Re: Initial Submission Review – East Bank Shopping Center Residential (Application #: DA-1207-11) (Case #: 1992-6001-24; 2021-3018-00)

Initial Submission Review

Sheet 6 of 29

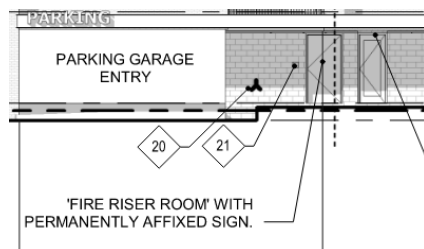
10C. See comment for legend, symbol and location of FDC, Knox Boxes and Exterior riser room door.

Response: *FDC, Knox box and exterior riser room called out on Site Plan and Utility Plan.*
